Access Compliance Report

Public Rights-of-Way

Intersection ID: 32301	Main Street: BAILEYWICK_RD	Cross Street: HAZELVIEW_DR	Location: NW
ADA ID: 6FE7CF397B43	Ramp Type: PerpDiag	Initial Pass/Fail: Fail	Overall Compliance: No
		Severity Score: 12.5

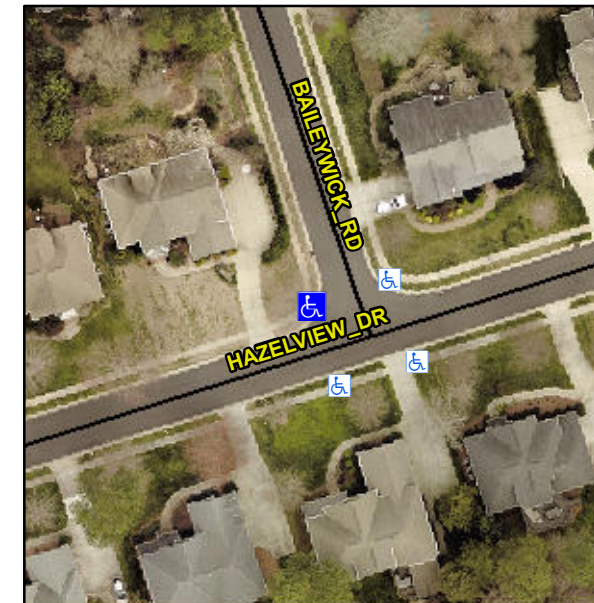
Not Found, R304.5.3

Compliance	Description	Data	Compliance	Description	Data
N/A	Ramp Length (in)	99.0	Yes	Ramp Slope (%)	7.3
Yes	Ramp Width (in)	48.0	No	Ramp XSlope (%)	5.8
N/A	Flare Type LT	N/A	N/A	Flare Type RT	N/A
N/A	Flare Slope LT (%)	N/A	N/A	Flare Slope RT (%)	N/A
N/A	Flare Traversable LT?	N/A	N/A	Flare Traversable RT?	N/A
N/A	Landing Length (in)	N/A	N/A	DWS Provided?	N/A
N/A	Landing Width (in)	N/A	N/A	DWS Contrast?	N/A
N/A	Landing Slope (%)	N/A	N/A	DWS Length (in)	N/A
N/A	Landing X Slope (%)	N/A	N/A	DWS Full Width?	N/A
N/A	Landing Curb? (Y/N)	N/A	N/A	DWS Offset (in)	N/A
N/A	Shared Landing?	N/A			
N/A	Gutter Ponding?	N/A	N/A	Gutter Slope (%)	N/A
N/A	Gutter Lip Ht (in)	N/A	N/A	Gutter X Slope (%)	N/A
N/A	Painted X Walk1?	No	N/A	Painted X Walk2?	No
	X Walk 1 Direction	To S		X Walk 2 Direction	To E
N/A	X Walk 1 Width (in)	N/A	N/A	X Walk 2 Width (in)	N/A
	X Walk 1 Slope (%)	1.8		X Walk 2 Slope (%)	2.3
	X Walk 1 X Slope (%)	2.6		X Walk 2 X Slope (%)	0.8

Remove & Replace Curb Ramp With Two New Directional Ramps or Equivalent.
